THREE MILE ISLAND NUCLEAR STATION, UNIT NO. 1

AMENDMENT TO FACILITY OPERATING LICENSE

Amendment No. 164  
License No. DPR-50

ATTACHMENT TO LICENSE AMENDMENT NO. 164

Figure 5-4 Relationship between Initial Enrichment and Acceptable Fuel Burnup (Spent Fuel Pool A - Region II)

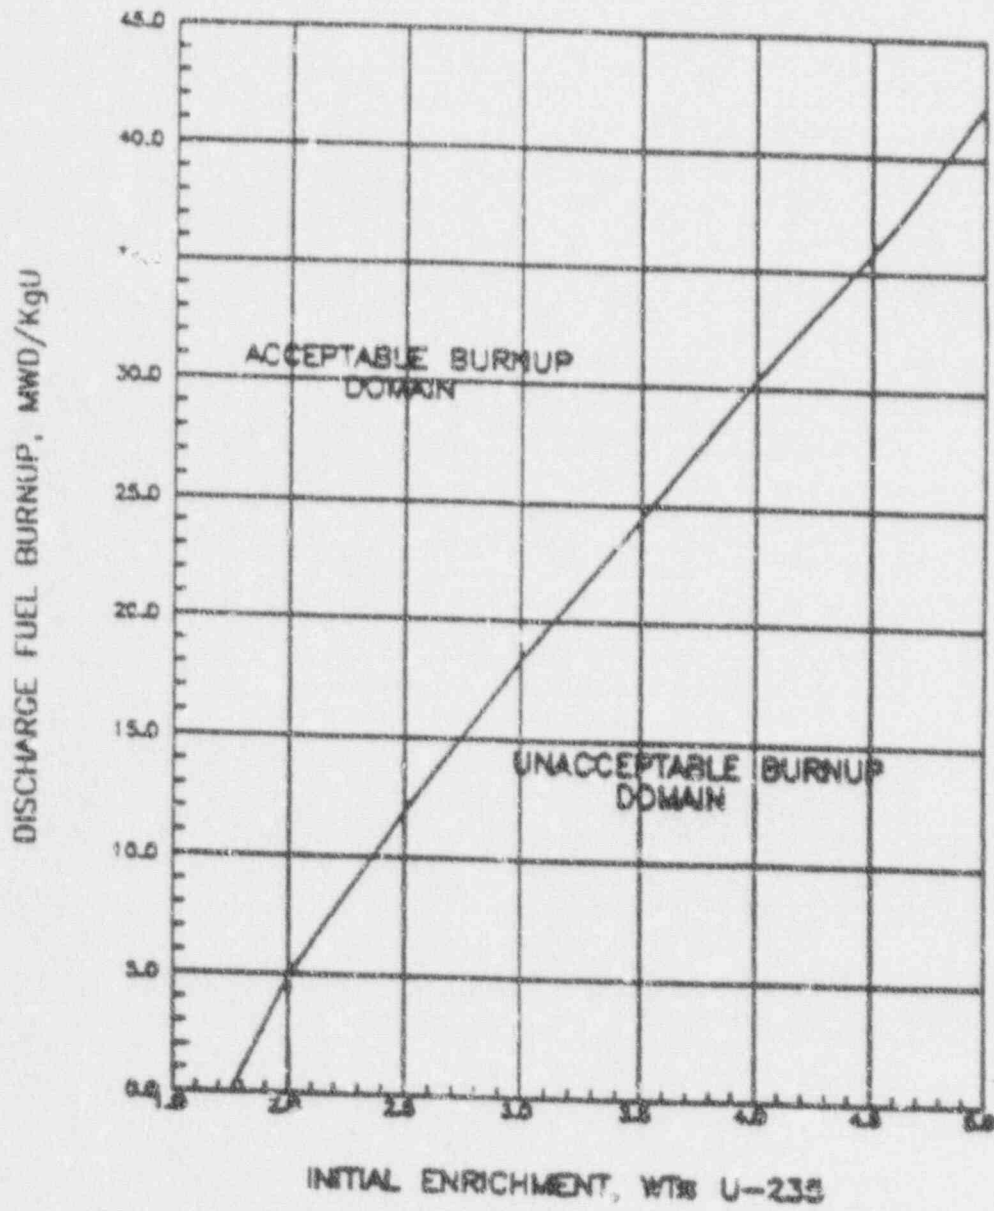
- \* The "B" pool fuel storage racks are designed using the floor response spectra of the Fuel Handling Building.
- f. Fuel in the storage pool shall have a U-235 loading equal to or less than 57.8 grams of U-235 per axial centimeter of fuel assembly.
- g. When spent fuel assemblies are stored in Region II storage racks of the Spent Fuel Pool "A", the combination of initial enrichment and cumulative burnup for spent fuel assemblies shall be within the acceptable area of Figure 5-4.
